SUBJECT: MCPC #24-0167-002
230 Church Road SOPI Submission

Re: MCPC #24-0167-001
Plan Name: 230 Church Rd
(2 dus/2 lots on approximately 0.25 acres)
Situate: Church Road (west); south of Montgomery Avenue
Lower Merion Township

- Attachment A -

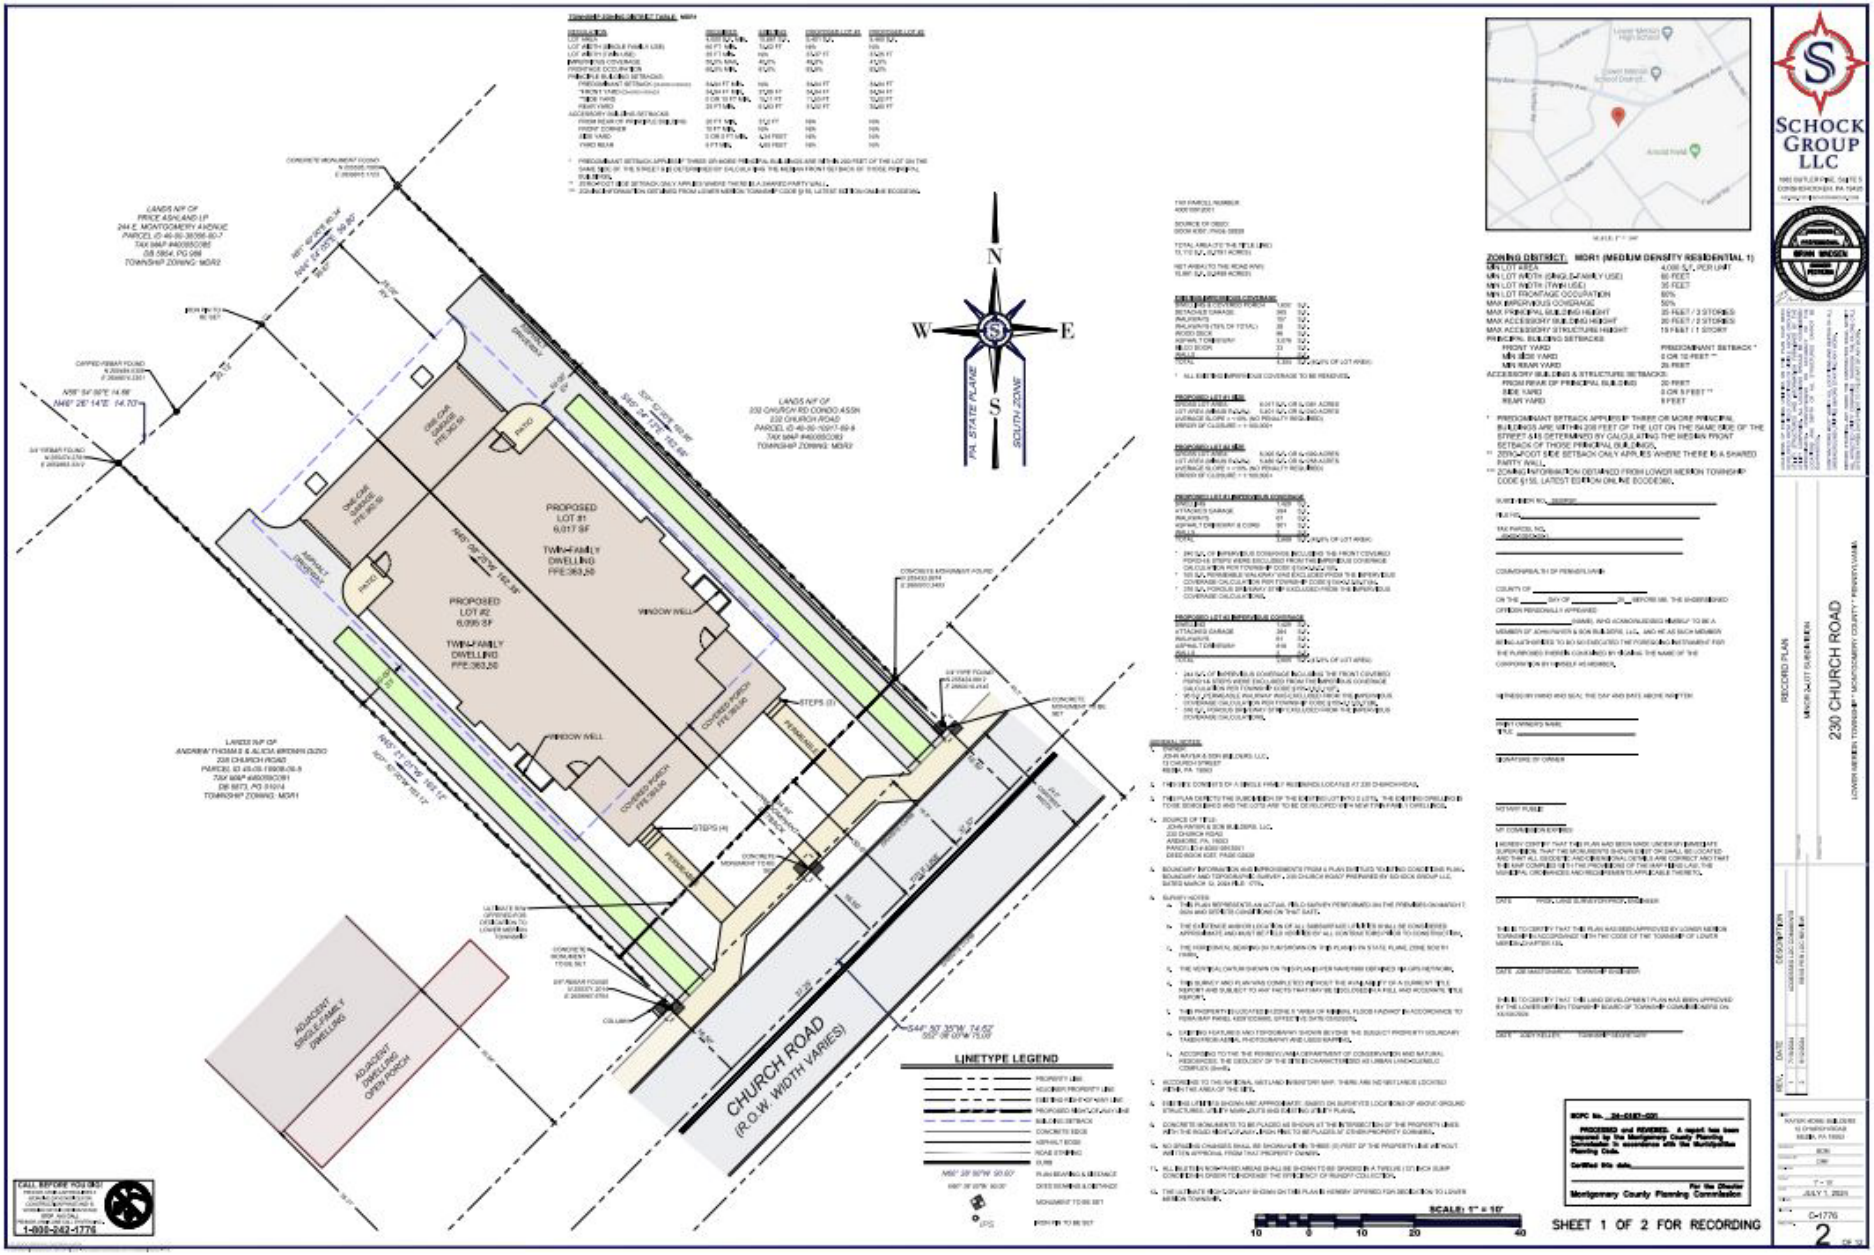
We have reviewed the most recent "SOPI" submission for changes and noted that the proposed land use and the number of units proposed remains the same. The streetscape design has been modified to create a five-foot wide sidewalk with a five-foot wide verge between the sidewalk and the curb.

We have reviewed the most recent "SOPI" submission and feel that several comments from our August 16, 2024 review letter may still be worthy of discussion. Specifically, we wish to reiterate our previous comments related to ensuring a sufficient tree protection zone is provided around the 22" oak tree proposed to remain along the rear property line and that the proposed plantings in the rear buffer area have sufficient growing space given their close proximity to the underground stormwater management facilities.

BUILDING SETBACK
CONCRETE EDGE
ASPHALT EDGE
ROAD STRIPING
CURB
PLAN BEARING & DISTANCE
DEED BEARING & DISTANCE
MONUMENT TO BE SET
IRON PIN TO BE SET
SCALE: 1" = 10'
SCHOCK GROUP LLC
230 CHURCH ROAD
RECORD PLAN
MINOR LOT SUBDIVISION
LOWER MERION TOWNSHIP * MONTGOMERY COUNTY * PENNSYLVANIA
C-1776

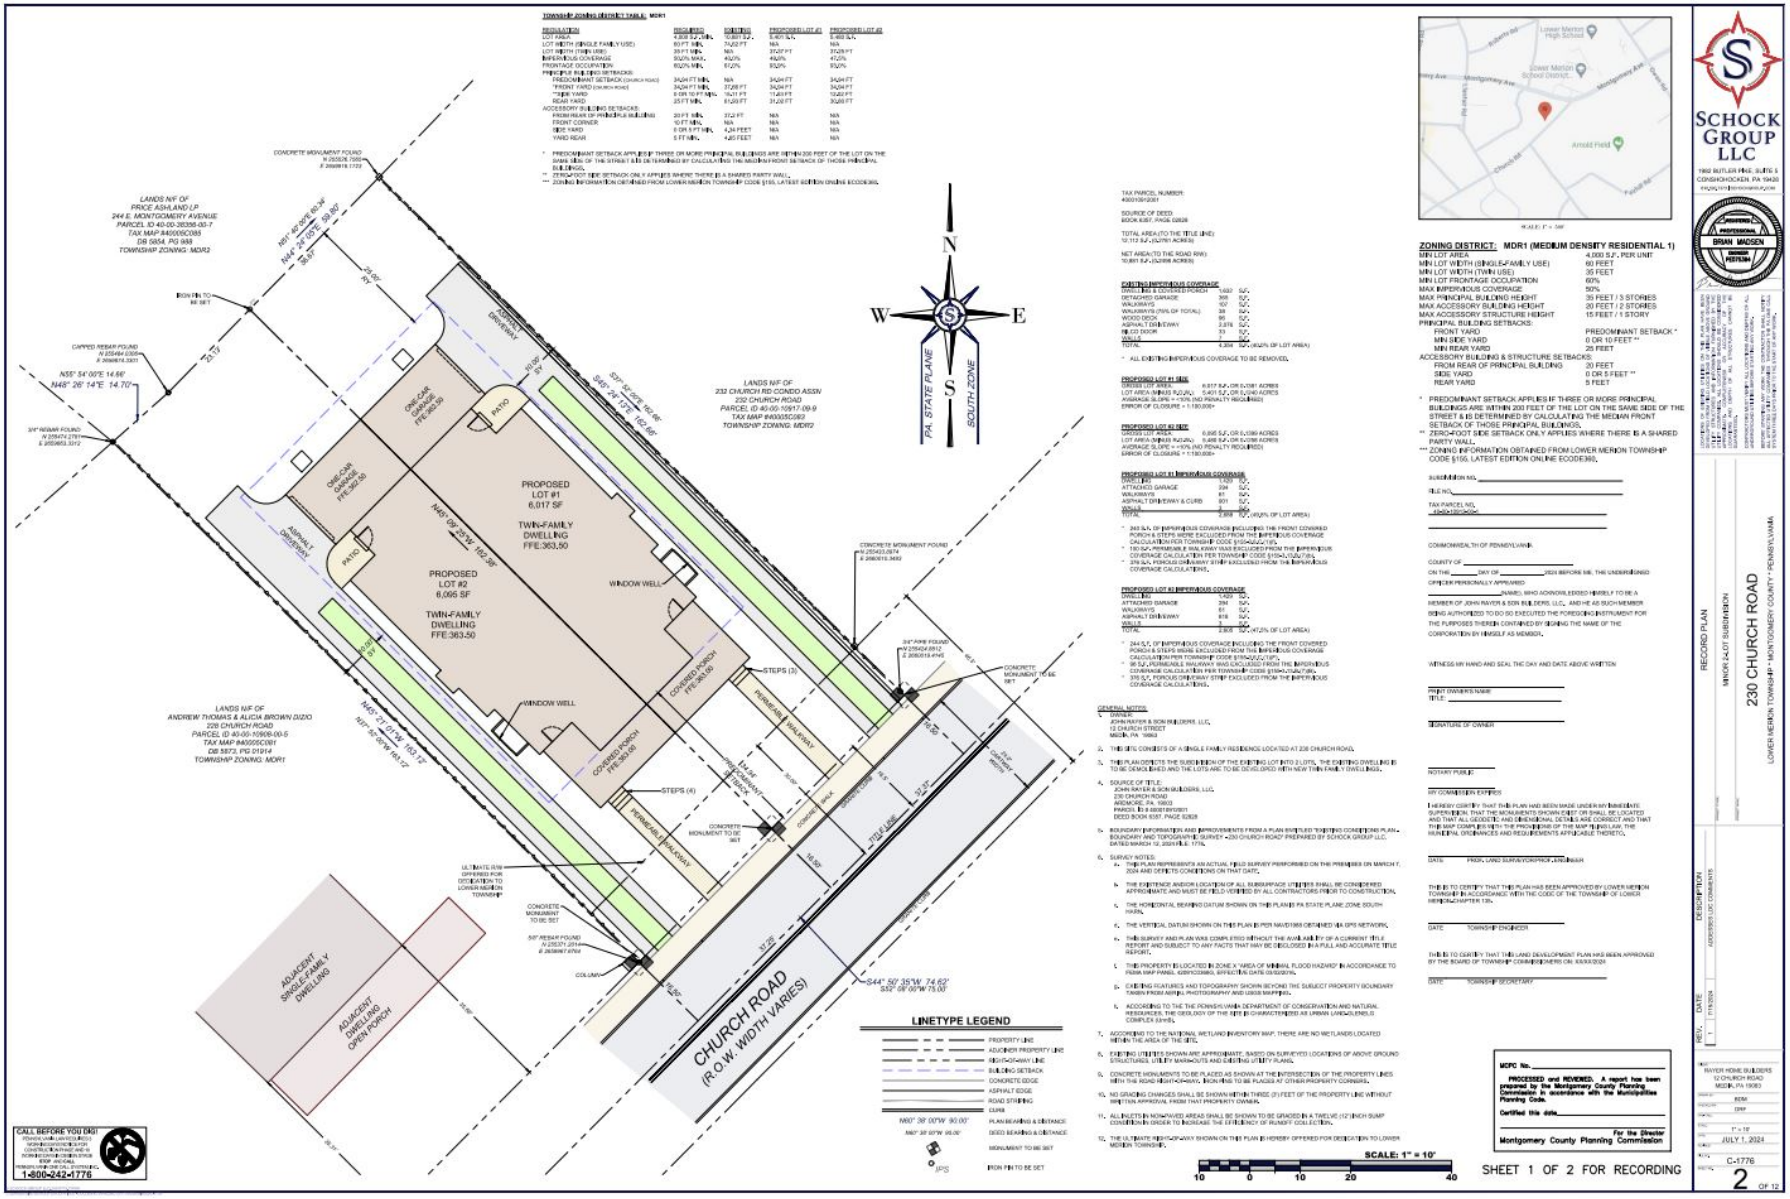
A. Sidewalk and Verge Requirements. According to the Official Highway Map (Map C2) in the Circulation Element of the township's comprehensive plan, Church Road is a secondary arterial road. Section 135-4.9.C.(1) and Table 4.9.1. of the township's subdivision and land development ordinance requires a minimum of a 5-foot wide verge and a 5-foot wide sidewalk along secondary arterial roads. It appears that a sidewalk of approximately 5 feet in width is proposed, but no verge is shown.

B. Buffer Plantings. Table 5.2.2. establishes the minimum requirements for each buffer type. It appears that the applicant proposes to utilize Option 2 for a Limited Area Buffer along the side property lines. A note on the plan indicates that a 4 to 6-foot tall solid fence is proposed along the side property lines. Option 2 for a Limited Area Buffer also requires "perennials and grasses sufficient to screen 50% of the linear length of the proposed fence at the time of planting." It does not appear that any perennials or grasses are proposed to be planted.

C. Minimum Species Diversity. Section 135-5.8.A.(6) and Table 5.8.1. establish the minimum species diversity requirements. Based on the information provided in the plant schedule on Sheet L-1, it does not appear that the minimum species diversity requirement is being met for all proposed plant types. Specifically, because a total of 22 shrubs are proposed, four shrub species are required; however, only two shrubs species are proposed.

D. Minimum Soil Volume. Section 135-5.8.C. establishes the minimum soil volume for canopy trees that are proposed to be planted within planting areas of 1,000 square feet or less in area. Future submissions should include information demonstrating compliance with this requirement for the proposed street trees in the front yard areas.

Section 101-6.A. of the Natural Features Conservation code requires that tree protection fencing shall be placed at the dripline around trees to be retained within 25 feet of a building site, parking area or other proposed improvement. The tree protection fencing, as well as the proposed temporary sediment basin and grading, shown on Sheet 8 appears to be located within the dripline of a 22" tree that is proposed to remain along the rear property line.

It appears that an underground stormwater management facility is proposed in the rear yard of each lot. From the information provided, it is unclear where any overflow from the stormwater management facilities would be piped or discharged to, if applicable.

Related to the location of the proposed underground stormwater management facilities, a temporary sediment basin appears to be proposed to be located on the same area of the site during construction. We recommend that the applicant work closely with the Montgomery County Conservation District to ensure proper precautions

The required buffer plantings, including two understory trees, are shown to be planted in a very narrow space between the underground stormwater management facilities and the rear property line. We encourage the applicant to explore alternative site layouts, such as shifting the underground stormwater management facilities away from the rear property line, to provide adequate growing space for the proposed buffer plantings.
